General Information
(see reverse for instructions)

Name of Project	Franklin Hills Estates & Country Club	CGP Tracking No.	IR #20-10	Inspection Date	1/4/2021
Inspector Name, Title & Contact Information	Inspector: David C. McKay, P.E.		Reviewer: David McKay, P.E.		
Present Phase of Construction	Phase 1				
Inspection Location (if multiple inspections are required, specify location where this inspection is being conducted)	Areas of Concern as defined at site walk with wetlands commission				
<p>Inspection Frequency (Note: you may be subject to different inspection frequencies in different areas of the site. Check all that apply.)</p> <p>Standard Frequency: <input type="checkbox"/> Weekly <input type="checkbox"/> within 24 hours of a 0.5" rain</p> <p>Increased Frequency: <input type="checkbox"/> Every 7 days and within 24 hours of a 0.5" rain (for areas of sites discharging to sediment or nutrient-impaired waters or to waters designated as Tier 2, Tier 2.5, or Tier 3)</p> <p>Reduced Frequency:</p> <ul style="list-style-type: none"> - <input checked="" type="checkbox"/> Once per month (for stabilized areas) - <input type="checkbox"/> Once per month and within 24 hours of a 0.5" rain (f

Photo 1: Stone check dam immediately upgradient of main entry water crossing has flattened due to A1V traffic and has reached capacity with collected sediment.

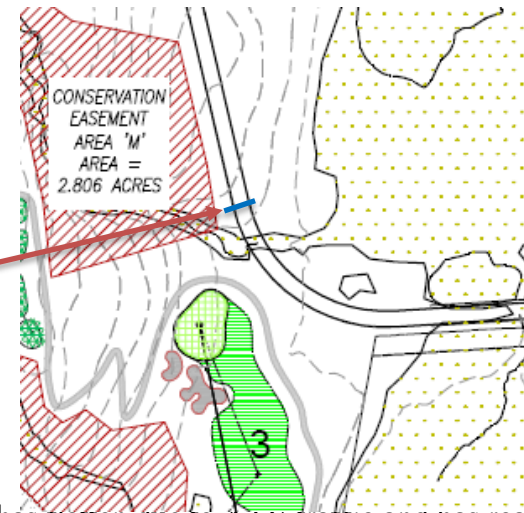
1. Main Entry Water Crossing (Northerly of 3 rd Hole Green)	<input checked="" type="checkbox"/> Yes <input type="checkbox"/> No	<input type="checkbox"/> Yes <input checked="" type="checkbox"/> No		Stone check dam immediately upgradient of crossing has been partially flattened due to trespassing ATVs and has reached full capacity (Photo 1). Stone check dam in trail leading down to crossing has reached capacity (Photo 2). Both check dams need accumulated sediment removed and minor repair. Additional check dams could be added along the trail could be added to address channelized flow in tire ruts.

Photo 3: Some sediment fence repairs are needed for undermining at upper and lower sediment fence rows. Intermediate sediment fence through sapling stand is beginning to fail and should be restaked. Sediment should be removed from check dams.

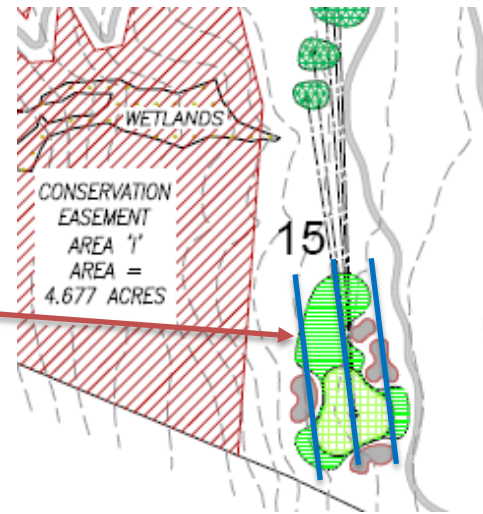
2. 15 th Green Sediment Barriers	<input checked="" type="checkbox"/> Yes <input type="checkbox"/> No	<input type="checkbox"/> Yes <input checked="" type="checkbox"/> No		Downgradient stone check dam remains in good condition. Sediment fence along the cart path and along the tree line have undermined in two locations each and should be repaired. Check dams should have collected sediment removed. Intermediate fence needs to be restaked. (Photo 3). Sediment fence rows and staked hay bales in south end have deteriorated and need to be replaced (Photo 4).

Photo 5: Stone check dams and staked hay bales are in good condition. Collected sediment should be removed and sediment fence repaired.

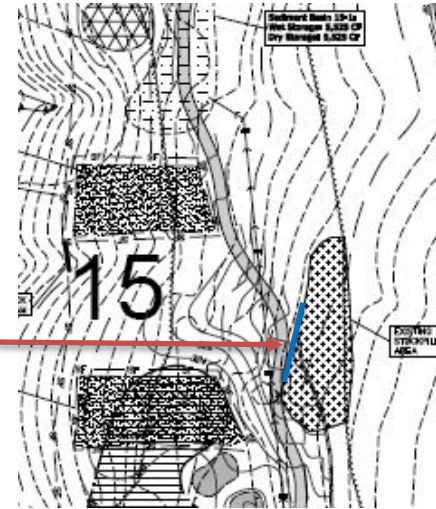
3. 15 th Fairway Sediment Barriers	<input checked="" type="checkbox"/> Yes <input type="checkbox"/> No	<input type="checkbox"/> Yes <input checked="" type="checkbox"/> No		Stone check dams, stone apron are in good condition and functioning as intended. Collected sediment should be removed (Photo 5). Sediment fence has been downed and should be repaired.

Photo 6: Recently constructed swale carrying flow to downgradient drainage structure. No signs of erosion in swale.

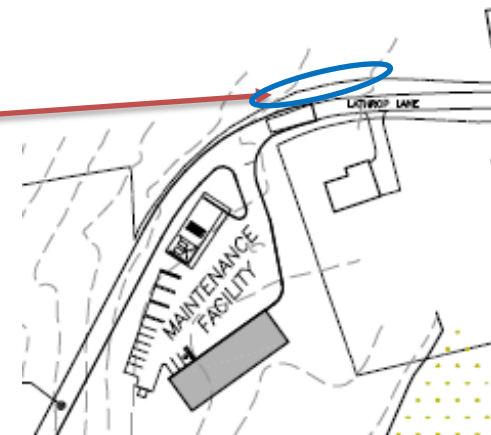
4. Construction Entrance (Westerly of Proposed Maintenance Road)	<input checked="" type="checkbox"/> Yes <input type="checkbox"/> No	<input type="checkbox"/> Yes <input checked="" type="checkbox"/> No		Stone check dam and water bar across construction entrance are in good condition and functioning. Staked hay bales and sediment fence are deteriorating and have been removed from flow path (Photo 6). Diversion swale excavated to downgradient drainage structure was carrying flow and does not show signs of erosion. Stone check dams should be added to new swale if erosion occurs.

Photo 7: Stone check dams across the 7th hole fairway hillside remain in good condition. Sediment fence rows and hay bales have deteriorated. Since upgradient areas are vegetated the sediment fence could be replaced with additional stone check dams to prevent erosion from channelized flows..

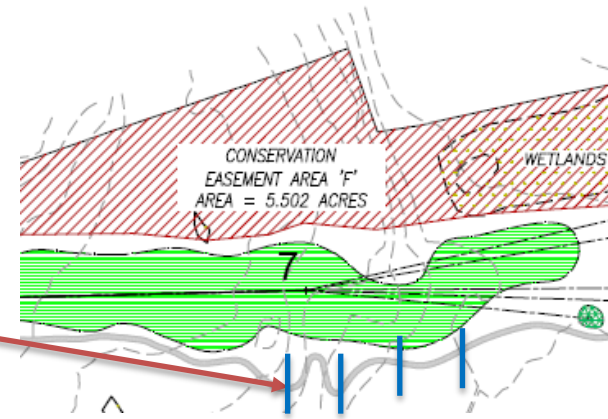
5. 7 th Hole Fairway Hillside	<input checked="" type="checkbox"/> Yes <input type="checkbox"/> No	<input type="checkbox"/> Yes <input checked="" type="checkbox"/> No		Check dams across 7 th Hole fairway are in good condition overall and functioning as intended (Photo 7). Sediment fence has failed in several locations however given the upgradient vegetation failed sediment fence could be replaced with stone check dams instead of repairing.

Photo 8: Sediment fence row across 11th hole tee box area has been knocked over by ATV traffic.

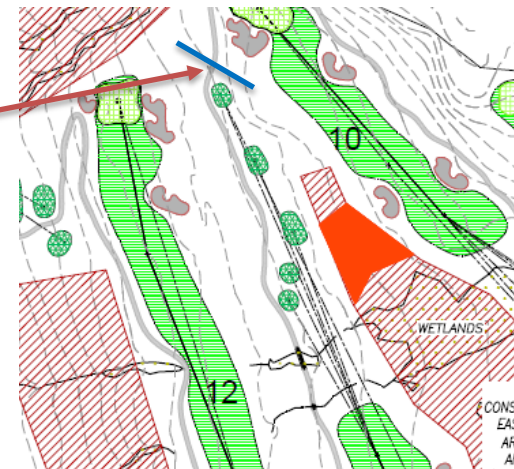
6. 11 th Hole Tee Box Area	<input checked="" type="checkbox"/> Yes <input type="checkbox"/> No	<input type="checkbox"/> Yes <input checked="" type="checkbox"/> No		Sediment fence row across path by 11 th Hole tee box has failed due to ATV traffic (Photo 8). At time of inspection the area was stable except for tracking and rutting due to ATV traffic. Stone check dams could be installed across ATV track to disrupt channelized flow.

Photo 9: Sediment fence at tree line by 14th hole is allowing flow underneath in one location and should be repaired. An additional stone check dam could be added upgradient of protected area to disrupt channelized flows.

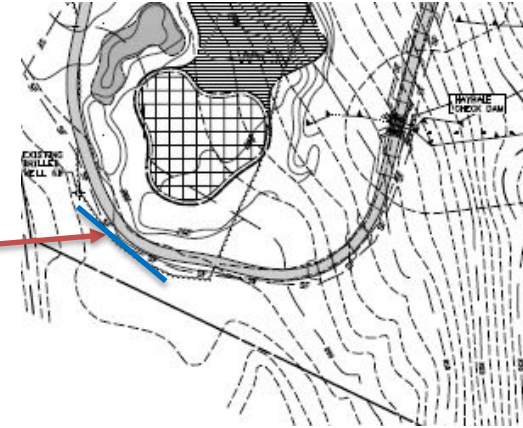
7. 14 th Hole Green Sediment Barriers	<input checked="" type="checkbox"/> Yes <input type="checkbox"/> No	<input type="checkbox"/> Yes <input checked="" type="checkbox"/> No		Sediment fence row at tree line is allowing flow underneath in one location and needs to be corrected (Photo 9). Additional flow paths have begun along the cart path and a stone check dam should be added at the undermined sediment fence.
